Draft Final

Demonstration of Surfactant-Enhanced Aquifer Remediation of Chlorinated Solvent DNAPL at Operable Unit 2, Hill AFB, Utah

June 1997

Figure 3-2

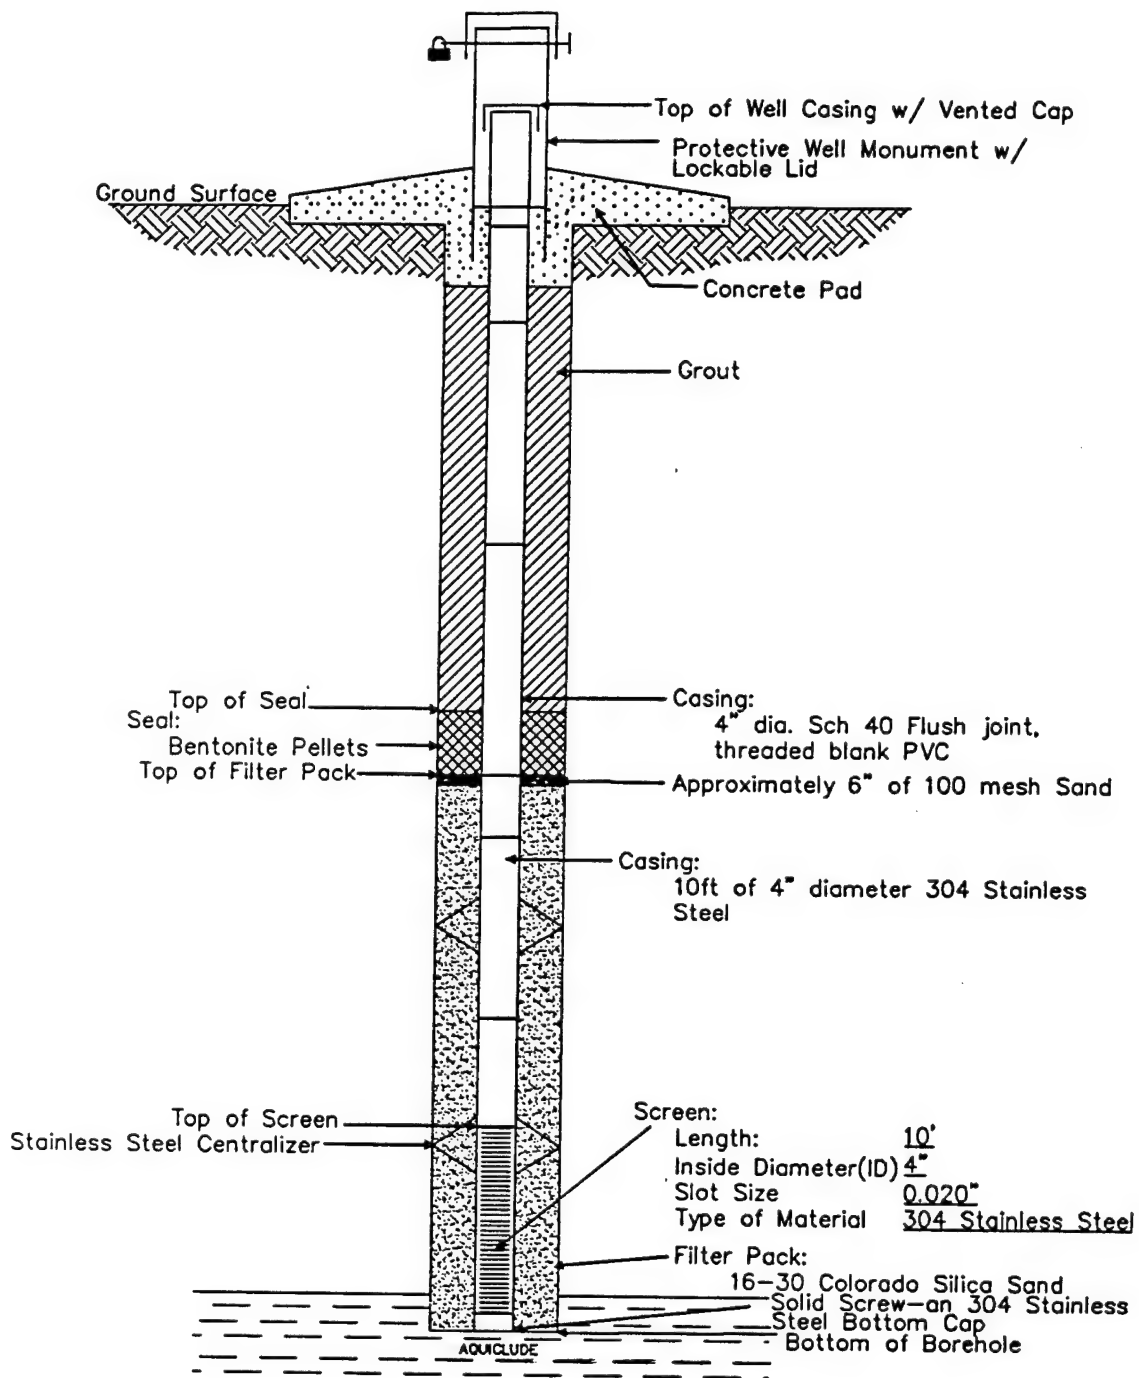
Item	Page	Section/ Paragraph	Line	Comment	Response/Action
1	3-8	Figure 3-2	NA	Correct this figure to show that the stainless steel casing was used for the first ten feet above the well casing.	The figure has been corrected and is attached for review.
2	3-21	Figure 3-7	NA	The labels for the test wells are difficult to read. Provide clear labels for the wells to orient the reader.	The figure has been revised and is attached for review. The well labels have been changed and the shading has been removed to make them more legible. A north arrow and axis labels have been added to orient the reader. The page size has been increased to an 11x17 format.
3	3-28	4	3	The second sentence in this paragraph is duplicated. Correct the text.	The duplicate sentence has been removed.
4	3-29	2	3	Provide a complete reference for Mariner et al., 1997.	The list of references has been updated to include Mariner et al., 1997. The revised Section 10.0 is attached for your review.

Figure 7-9

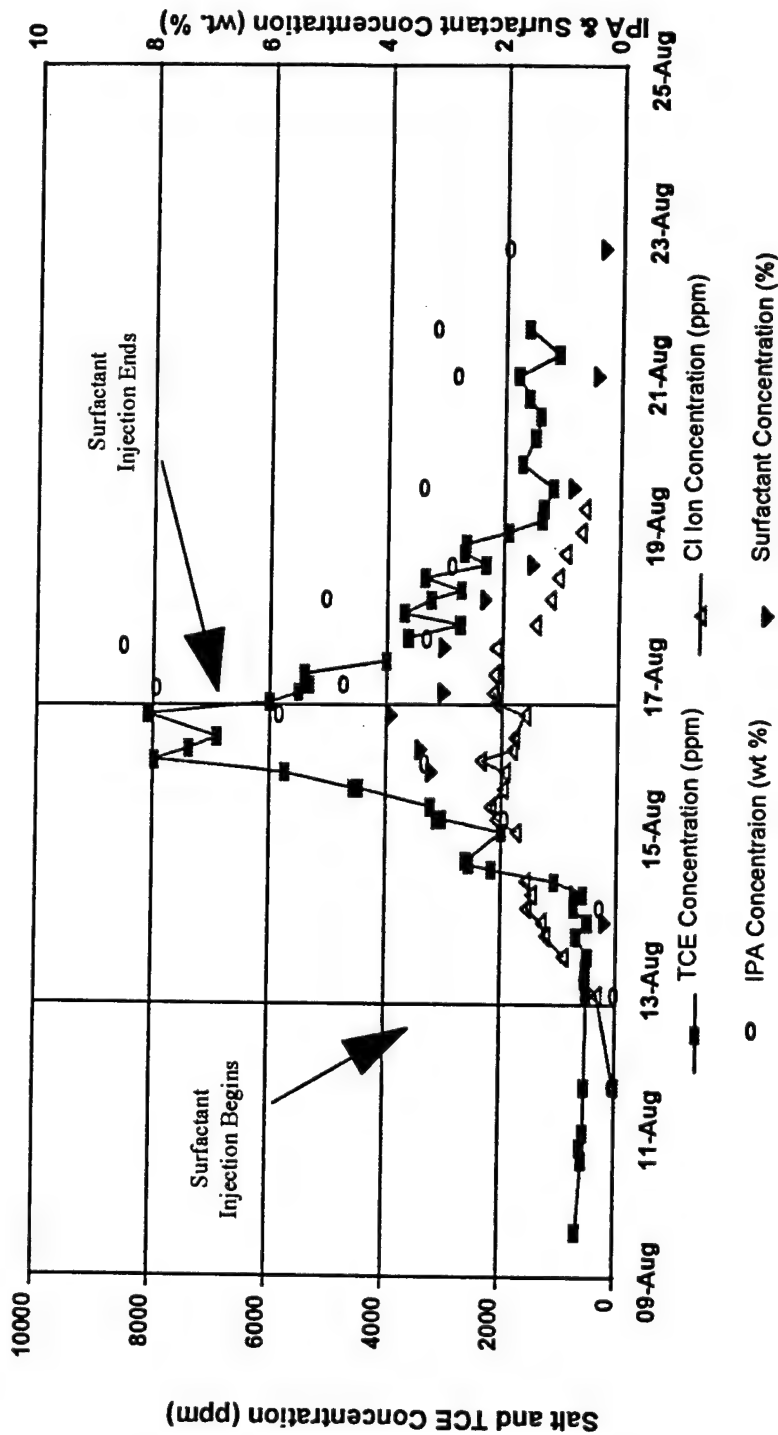
30	7-17	4	7	The phrase "to the stripper" is duplicated in this sentence. Correct the text.	The duplicated phrase has been removed from the sentence.
31	7-21	Figure 7-9	NA	No data are provided for isopropyl alcohol concentration, and the symbol is not shown in the legend. Provide the data, and correct the legend.	The graph and legend have been corrected to include isopropyl alcohol. The revised figure is attached for review.
32	7-22	2	4	The text states that baseline (no surfactant) conditions were modeled, but no results are presented. Modify the text to include the baseline modeling results.	The quoted statement is misleading. The sentence stating that baseline modeling had been conducted has been deleted.
33	7-23	Figure 7-10	NA	No data are provided for measured TCE effluent (parts per million), and the symbol is not shown in the legend. Provide the data, and correct the legend.	The graph and legend have been corrected to include measured TCE concentration. The revised figure is attached for review.

Figure 7-10

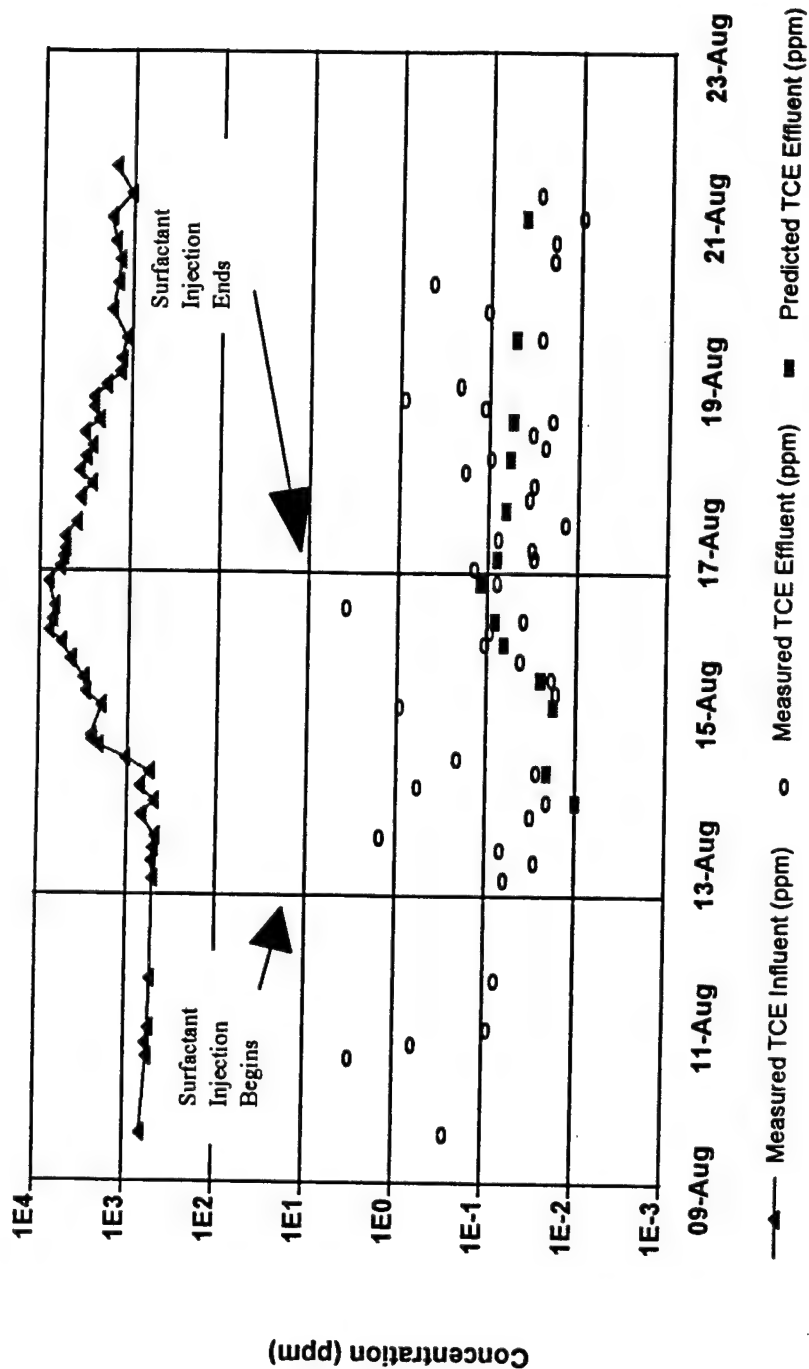
The measured TCE concentrations in the effluent from the steam stripper are shown in Figure 7-10. Results are provided for both grab samples collected from the stripper bottoms and cumulative samples collected from the 4,000 gallon effluent storage tank. Despite the high TCE concentrations to the stripper, the effluent remained well below the discharge limit of 16 ppm. The relatively poor observed performance prior to initiation of surfactant injection was due to operational problems with the treatment equipment, which were resolved before surfactant injection began.

As was done for the Phase I work, the measured influent concentrations and the recorded operating conditions were used to model the stripper performance with the ASPEN Plus simulation package discussed in Section 7.2.2. Figure 7-10 compares the model predictions with the measured data. Both baseline (no surfactant) and test conditions were modeled.
